Energy, Sustainability and Air Quality Consultation Response

Scheme address	8-10 Southampton Row and 1 Fisher Street
Planning reference number	2019/2536/P
Description of development	Change of use of 8-10 Southampton Row from temporary Crossrail offices (B1) to hotel with ancillary bar and restaurant (C1), together with erection of an 8 storey building at 1 Fisher Street, containing 9 self-contained residential units (C3) and hotel floorspace connected to 8-10 Southampton Row (85 hotel rooms in total across the site), following demolition of part of rear façade and other internal and external alterations to 8-10 Southampton Row. Installation of associated plant, refuse and cycle storage areas.
No. of residential units	9
Non-residential floor space (GIA m2)	4,321m2
Type of non-residential floor space	C1 - hotel
Building regulations requirements	Assessed under L1A/L2A
Relevant documents for reference	Energy Strategy Report Stage 2, RES, 15/5/19 Sustainability Statement, Ensphere, May 2019 Thermal Comfort Analysis CIBSE TM59:2017 and CIBSE TM49:2014 Southampton Row Residential Units, RES, 10/5/19 Air Quality Assessment, Royal HaskoningDHV, draft 10 May 2019

Recommendation	Further inf

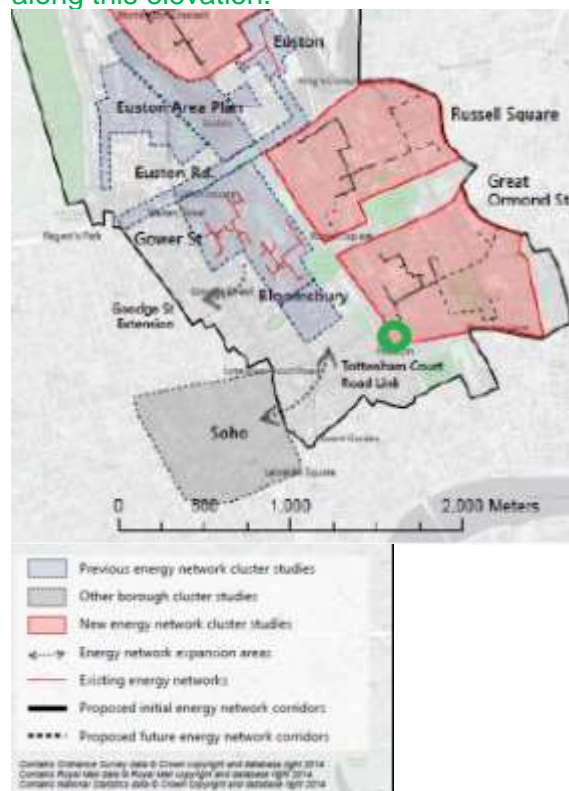
Issue 6: Sites within 1km of a potential network should future proof unless demonstrated to be unfeasible.

Action: Further information required including:

However, a soft punch point will be allowed for within the development and design will include allowances for HIU and appropriate isolation valves and metering.

It is expected that as the main thoroughfare, it is likely that a future district heat network would go along Southampton Row and as such all provisions will be made to allow connection along this elevation.

- Confirmation that the development is within 1km of a potential network **The development is not within 1km of a heat network based on the London Heat Map.**

- Floor plan of energy centre and layout of plant demonstrating safeguarded space for a future heat exchanger. This is being developed and will be provided during the next stage of design

- Confirmation that provision for external buried pipework routes from plant room to property boundary closest to expected route of network have been safeguarded. Details of these proposed pipe routes and connection points should be provided The required drawings showing safeguarded space will be provided during the next stage of design and will show detailed plant layouts and distribution routes including allowances for HUI, appropriate isolation valves and metering. It is expected that as the main thoroughfare, it is likely that a future district heat network would go along Southampton Row and as such provisions will be made to allow connection along this elevation.

- Details of provisions made in the building fabric/ design (such as soft-points in the building plant room walls) to allow pipes to be routed through from the outside at a later date a soft punch point will be allowed for within the development and design will include allowances for HIU and appropriate isolation valves and metering.

Figure 6 - Annual Heating Profile for the CHP system used for the hotel DHW demand

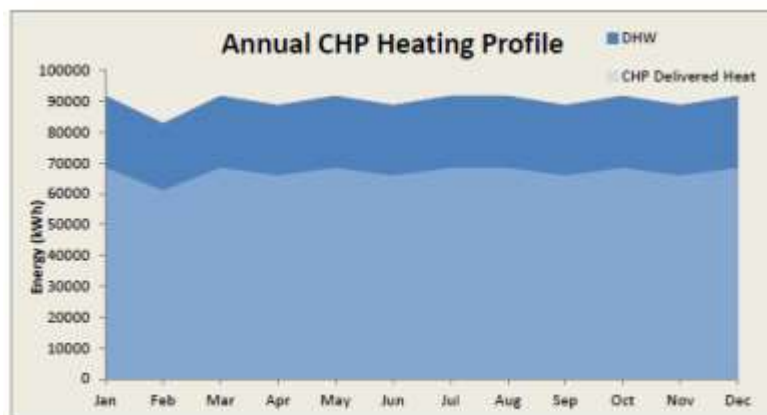
Issue 7: The applicant should provide further details to demonstrate the feasibility of CHP for the scheme. The heating profile should separate out space heat and hot water and include the ASHP and gas boilers. **Action: Further information required including:**

- Peak energy demands (kWh/year and kW) for the development for:
 - Heat demand (for hot water and space heating separately) **Included in Appendix B of the updated Energy Strategy**
 - Electricity demand (including unregulated energy) **Included in Appendix B of the updated Energy Strategy**
 - Cooling demand where district cooling is proposed **District cooling is not proposed**
- Details of the fuel used, including type of fuel and amount (kWh/yr). The applicant should review available heat sources and technologies including renewables and secondary heat sources where possible, with a comparison of whole life costs and contributions to CO₂ reductions. The applicant should take account of future trends in energy prices and decarbonisation, and

level of technology risk. electricity Details of CHP fuel consumption along with a payback period calculation (accounting for inflation to fuel prices) are included in Section 8.2.1 of the updated Energy Strategy. Alternative renewable/secondary heat sources are already included in Sections 8 and 9 (district heating, ASHP, and GSHP) and have discounted as discussed in the Energy Strategy,

- Details of standby and top up boilers Included in Section 8.2.1 of the updated Energy Strategy.
- Details of the proportion heat demand provided by CHP, thermal stores, boilers, and other technologies, illustrated as a heat profile showing monthly demand profiles and typical monthly design day profiles Included in Section 8.2.1 of the updated Energy Strategy.

Figure 11 - PV layout on the roof of the development

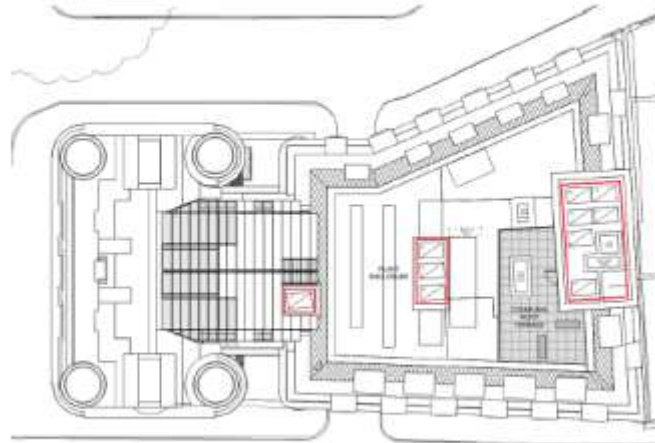
Issue 8: It is not clear from the layout information provided that all potential roof space has been used to maximise PV potential. **Action: Further information required.**

- Cross section and details of orientation. Once the final roof top and PV layout have been design a complete drawing will be submitted and will include plans and section across the roof, including the PV. The orientation, pitch and number of PV are included within Section 9 of the Energy Strategy as well as within Appendix C
- Assumptions for the calculations of expected electricity generation. Included in Section 9 and Appendix C of the updated Energy Strategy.
- Overshadowing impact assessment should be undertaken. The shading analysis should include an assessment of the height of existing buildings and any permissions granted for buildings near the application site. Included in Appendix C of the updated Energy Strategy.
- Maintenance details should be provided Included in Appendix C of the updated Energy Strategy.
